Supplemental Draft
Environmental Impact Report/Statement II

Monterey Peninsula Water Supply Project

ERRATA SHEET

SUPPLEMENTAL DRAFT EIR/EIS-II FOR THE MPWMD LONG-TERM WATER SUPPLY PROJECT U.S. Army Corps of Engineers, Permit Application #16516 S09 SCH #87092203

FIGURE 5-4

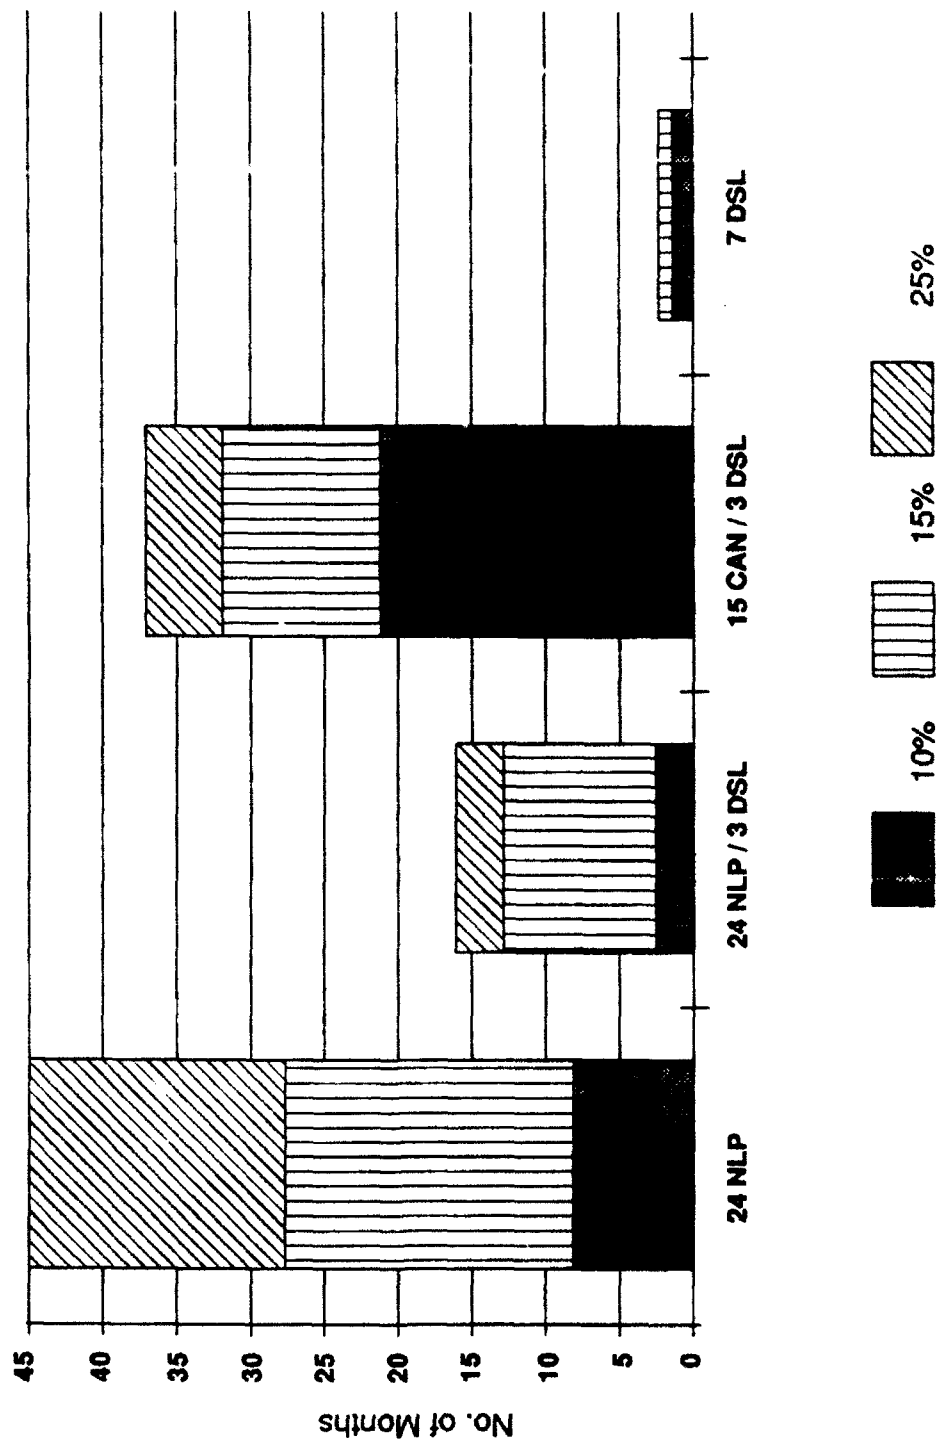
CHAPTER 5, page 5-15; Figure 5-4:
